Summary

A change per serial number HQ2150 results in a significantly increased chance of the Smart Solar MPPT 250/100 failing. It then fails with a dead short on the PV terminals, often during installation and a relay can be heard clicking at that moment.

SCC125110412 - SmartSolar MPPT 250/100-Tr VE.Can - per HQ2150xxxx onwards

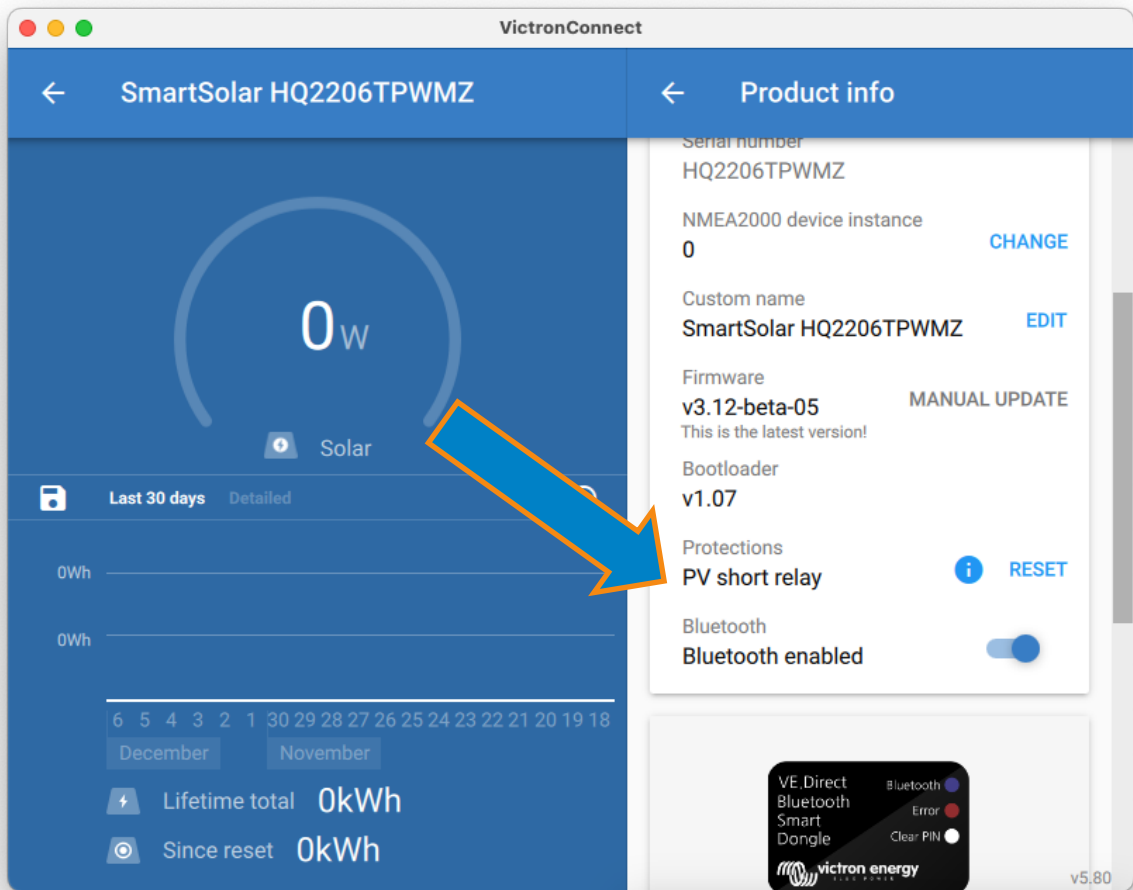
Reset procedure for PV Short Relay protection

1. Power the solar charger with a battery or bench power supply set to 12V.
2. Leave the PV Input terminals disconnected.
3. Open VictronConnect and navigate to the Product settings menu. There the PV Short reset feature is shown:

Note that the feature only shows when (a) the connected units features the protection, ie. 250/100 VE.Can model, HQ2150 and later; (b) requires the input voltage to be between 10 and 15V; (c) requires VictronConnect v5.80 or later and (d) requires firmware version v3.12 or later to be installed on the Solar Charger.

4. Then click the RESET button. It will gray out for a few seconds and return blue.
5. Verify with a multi meter, set to Ohms/continuity mode, that the PV Input terminals is no longer shorted.
